MARK	DATE	DESCRIPTIONS	BY	CH'D	CCO#
		REVISIONS			
6	03/07/14	INSTALL CALL BOXES	RG	AM	341S1
5	09/27/13	CALL BOXES	RM	AM	341
4	05/10/10	WEST END BARRIER CONDUIT	NK	MSO	44S1
3	08/03/09	ELECTRICAL WARNING SYSTEMS	GB	MSO	61
2	03/30/09	SERVICE PLATFORM ELECTRICAL CHANGES	NK	MSO	55
1	03/04/08	BARRIER MODIFICATIONS	EL	MI	44

CONTRACT CHANGE ORDER NO. 341 S1
SHEET 2 OF 14

BRIDGE NO. 34-0006
KILOMETER POST 13.2/13.9

SAS SUPERSTRUCTURE
ELECTRICAL PANEL SUPPORT SECTIONS
AS-13

DETAILS
SCADA REMOTE TERMINAL UNIT SYSTEM
RTU #11W ELEMENTARY AND CONNECTION DIAGRAM

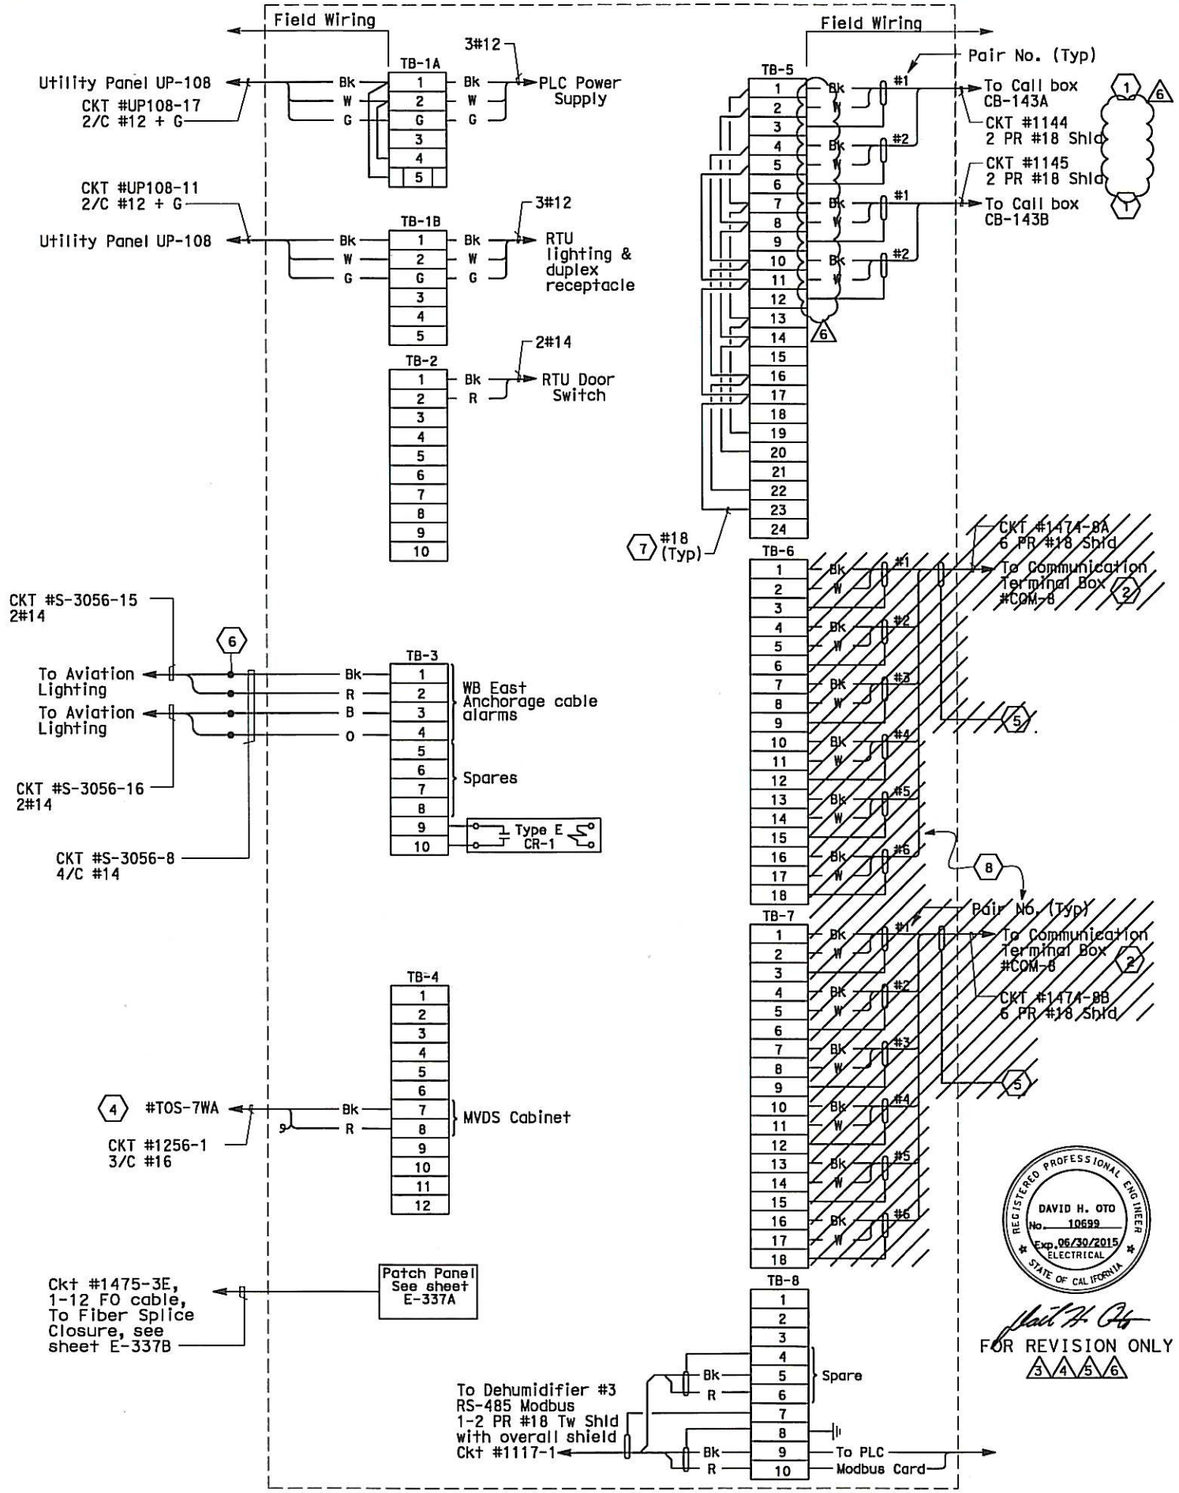
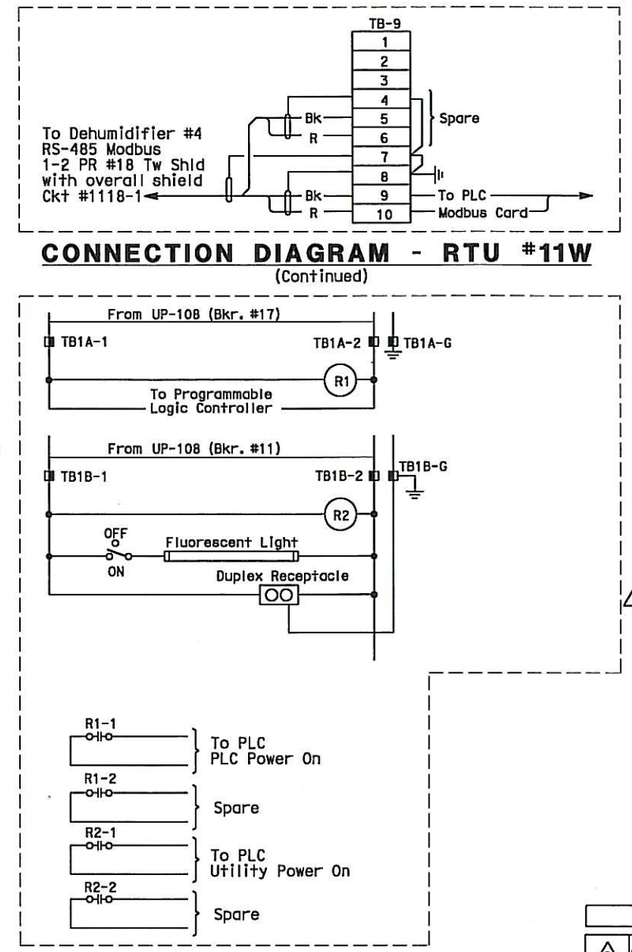
MARK	DATE	DESCRIPTIONS	BY	CH'D	CCO#
6	03/07/14	INSTALL CALL BOXES	EL	RG	341S1
5	09/27/13	CALL BOXES	RR RSB	RG	341
4	07/12/13	MISCELLANEOUS SCADA CHANGES	RR RSB	RG	305
3	05/13/13	MISCELLANEOUS SCADA CHANGES	RR RSB	RG	305
2	02/01/10	DEHUMIDIFIER SCADA INTERFACE	JE FW	RG	130
1	03/04/08	BARRIER MODIFICATIONS	JS BM	RG SE	44

1. For connection diagram to call boxes, see sheet E-398.
2. ~~For connection diagram to scada system, see Table A, sheet E-325.~~
3. For connection diagram to dehumification controllers, see sheets E-79.
4. Connections to panel door switch. For remote alarm status to RTU.
5. ~~Field to tape cable overall shield wire.~~
6. Conductors spliced inside junction box PB-2A located inside the girder.
7. The Contractor shall install resistors, approximately equal to the impedance (Zo) of the twised pairs, at the extreme ends of the multidrop network.
8. Abandon in place (hatched items) if installed.
9. Deleted.

DETAILS
SCADA REMOTE TERMINAL UNIT SYSTEM
RTU #11E ELEMENTARY AND CONNECTION DIAGRAM
NO SCALE

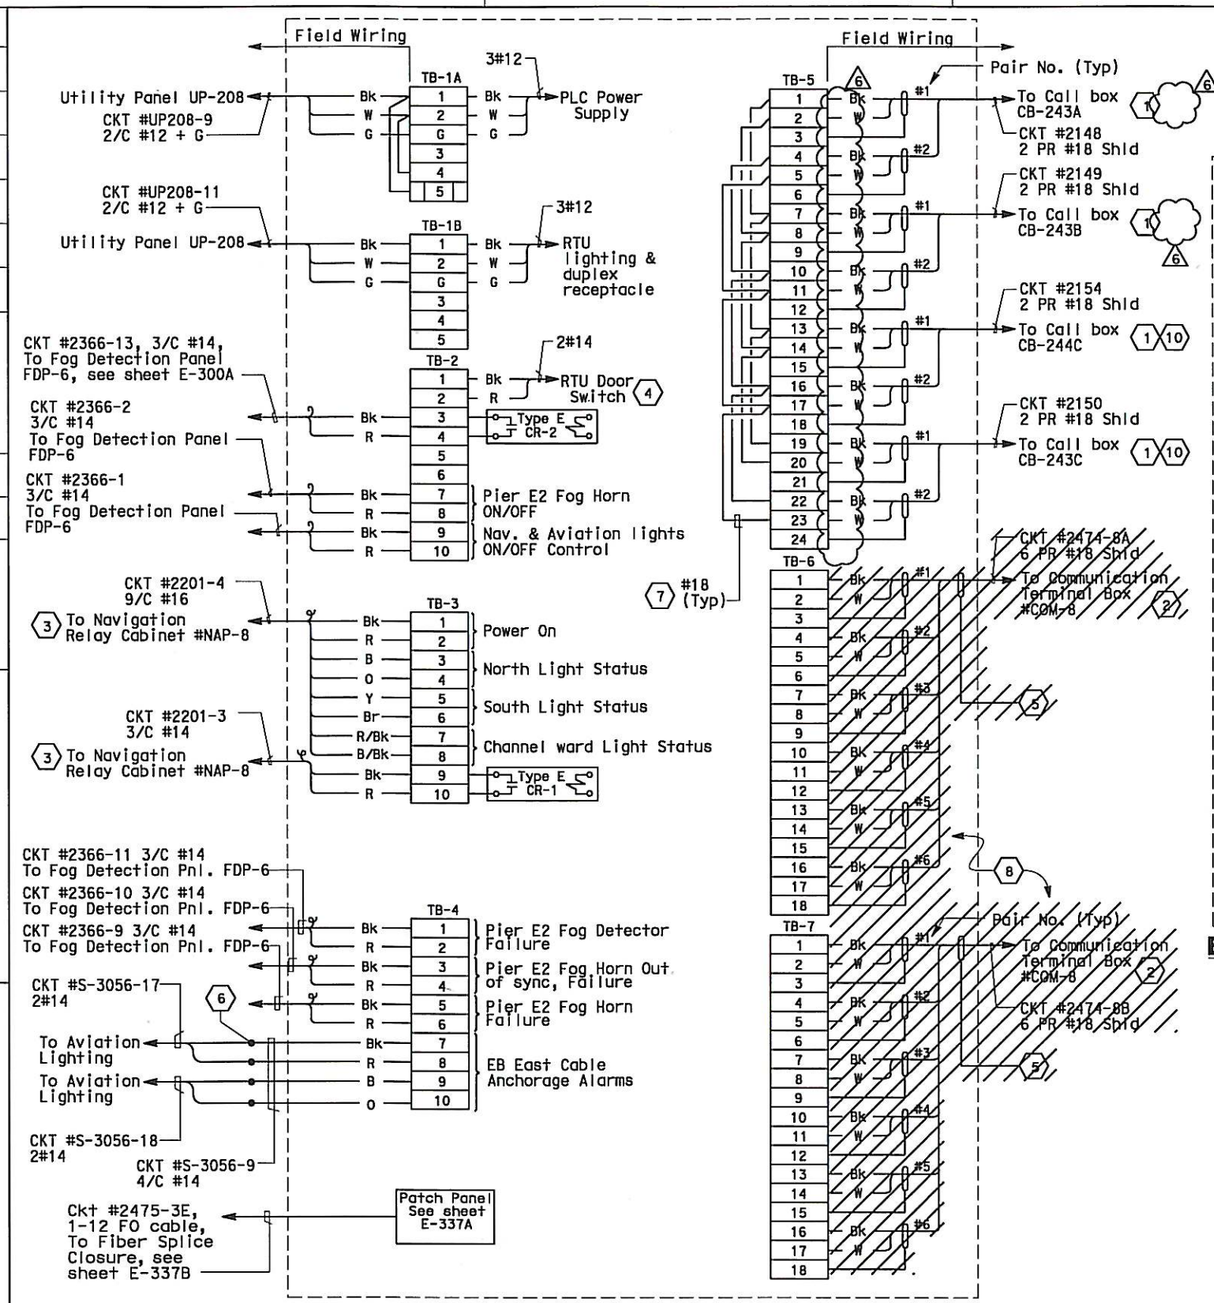
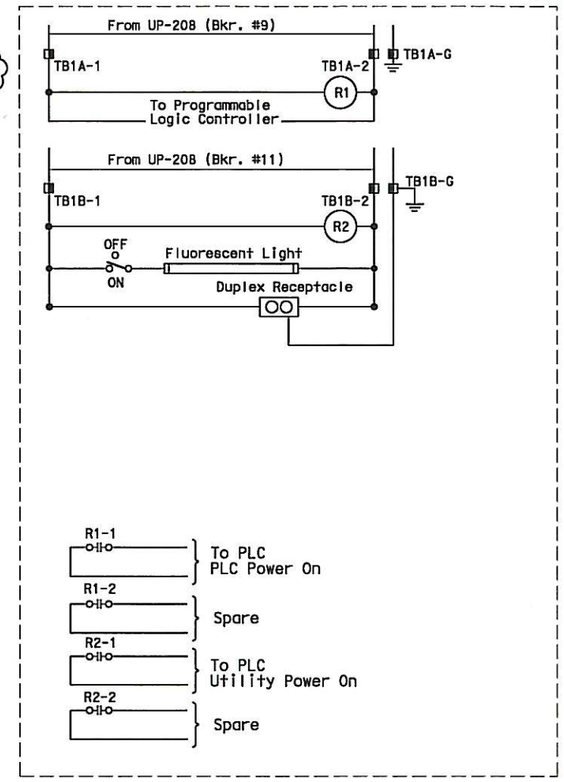
REQUEST FOR INFORMATION NOT ADDRESSED IN THIS CCO REMAIN IN FORCE					
6	03/07/14	INSTALL CALL BOXES	EL	RG	341S1
5	09/27/13	CALL BOXES	RR RSB	RG	341
4	07/12/13	MISCELLANEOUS SCADA CHANGES	RR RSB	RG	305
3	05/13/13	MISCELLANEOUS SCADA CHANGES	RR RSB	RG	305
2	08/03/09	ELECTRICAL WARNING SYSTEMS	RG	JE FW	61
1	03/04/08	BARRIER MODIFICATIONS	JS BM	RG SE	44
MARK	DATE	DESCRIPTIONS	BY	CH'D	CCO#
		REVISIONS

1. For connection diagram to call boxes, see sheet E-400.
2. ~~For connection diagram to scada system, see table A, sheet E-325.~~
3. For connection diagram to navigation system, see sheet E-303.
4. Connections to panel door switch. For remote alarm status to RTU.
5. ~~Field to tape cable overall shield wire.~~
6. Conductors spliced inside junction box PB-2A located inside the girder.
7. The Contractor shall install resistors, approximately equal to the impedance (Zo) of the twisted pairs, at the extreme ends of the multidrop network.
8. Abandon in place (hatched items) if installed.
9. Deleted.
10. Bike path call box is wireless. Communication cable shall be unterminated, coiled and taped inside RTU cabinet for future use, if installed.

CALL BOX SYSTEM
SAS SUPERSTRUCTURE LOCATIONS
SCALE 1:1000

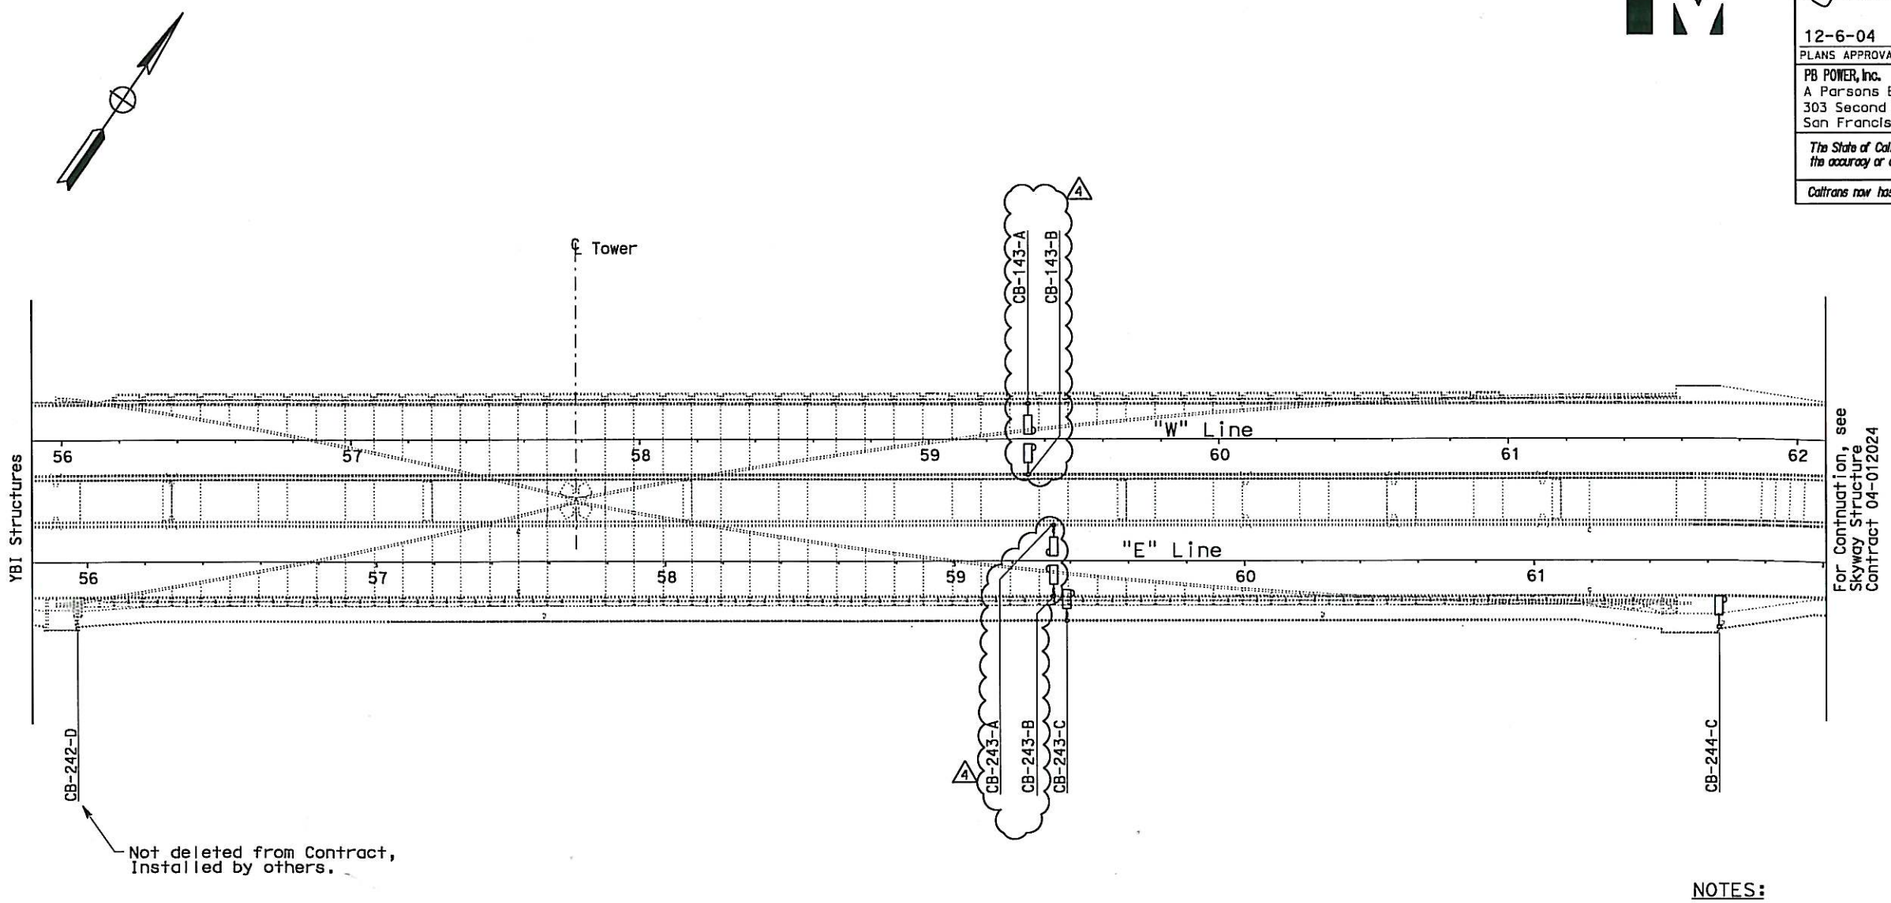
MARK	DATE	DESCRIPTIONS	BY	CH'D	CCO#
4	03/07/14	INSTALL CALL BOXES	EL	RG	341S1
3	09/27/13	CALL BOXES	RR RSB	RG	341
2	03/04/08	BARRIER MODIFICATIONS	JS BM	RG SE	44
1	02/19/08	ELECTRICAL MODIFICATIONS	MP EL	RR	42

1. References:
   - For call box conduit routing see sheets E-46 thru E-51 (WB), and sheets E-135 thru E-140 (EB).
   - For call box schedule, see sheet E-397.
   - For call box wiring diagrams, see sheet E-398 (WB), and sheets E-399 and E-400 (EB).
   - Call box are State-furnished and Contractor installed.

DETAILS
CALL BOX SYSTEM
CALL BOX WIRING DIAGRAM
NO SCALE

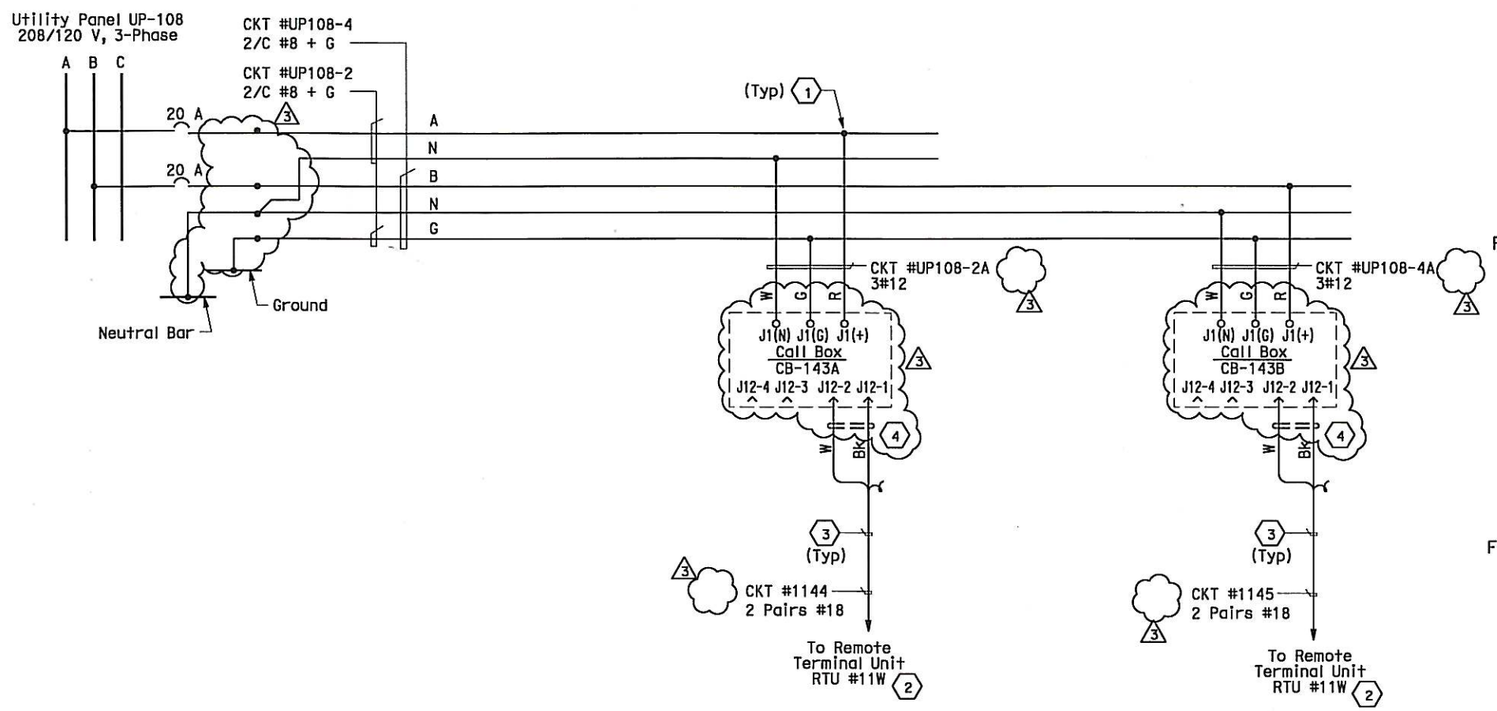
MARK	DATE	DESCRIPTIONS	BY	CH'D	CCO#
3	03/07/14	INSTALL CALL BOXES	EL	RG	341S1
2	09/27/13	CALL BOXES	RR RSB	RG	341
1	03/04/08	BARRIER MODIFICATIONS	JS BM	RG SE	44

1. Conductors spliced inside PB-Ltg.
2. For continuation, see RTU 11W connection diagram sheet E-332.
3. Data cable 1-2 pairs #18 shielded with overall shield. Coil and tape end of pair #2 inside Call Box.
4. The Contractor shall install resistors, approximately equal to the impedance (Zo) of the twised pairs, at the extreme ends of the multidrop network. (3)
5. Deleted.
6. Deleted.

DETAILS
CALL BOX SYSTEM
CALL BOX WIRING DIAGRAM
NO SCALE

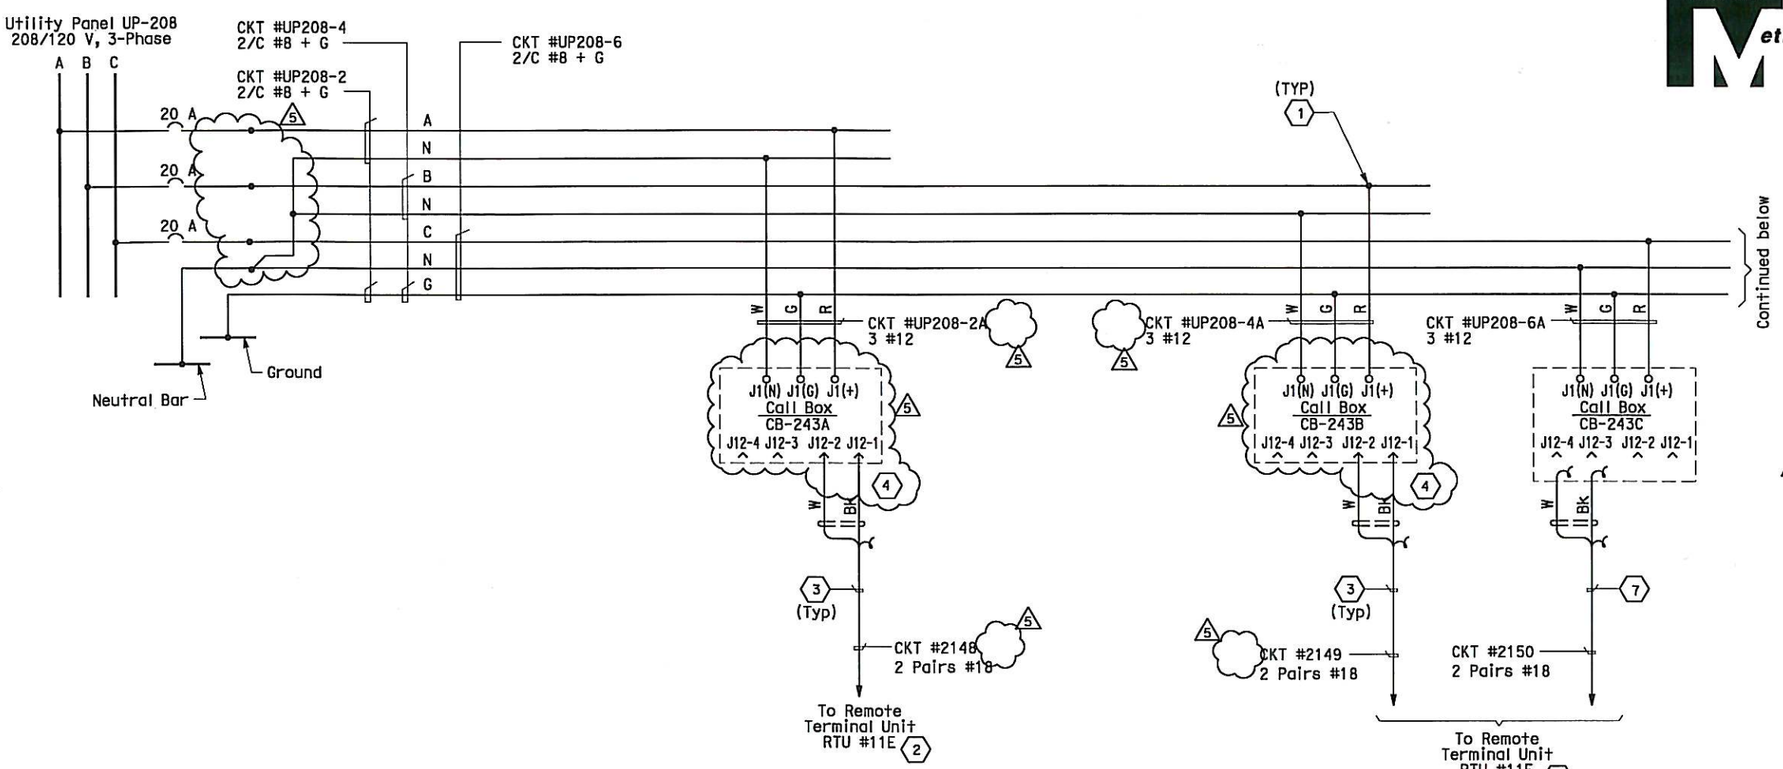
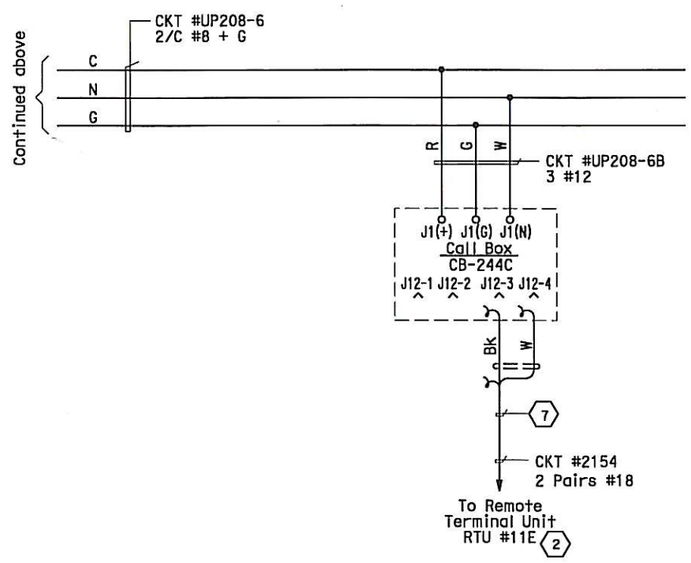
MARK	DATE	DESCRIPTIONS	BY	CH'D	CCO#
5	03/07/14	INSTALL CALL BOXES	EL	RG	341S1
4	09/27/13	CALL BOXES	RR RSB	RG	341
3	03/24/11	BIKE PATH CONDUIT	TW	RG	73
2	06/11/10	BIKE PATH CONDUIT	TW	RG	73
1	03/04/08	BARRIER MODIFICATIONS	JS BM	RG SE	44

1. Conductors spliced inside PB-Ltg.
2. For continuation, see RTU #11E connection diagrams sheet E-333.
3. Data cable 1-2 pairs #18 shielded with overall shield. Coil and tape end of pair #2 inside Call Box.
4. The Contractor shall install resistors, approximately equal to the impedance (Zo) of the twised pairs, at the extreme ends of the multidrop network.
5. Deleted.
6. Deleted.
7. Bike path call box is wireless. Communication cable shall be unterminated, coiled and taped inside call box for future use, if installed.
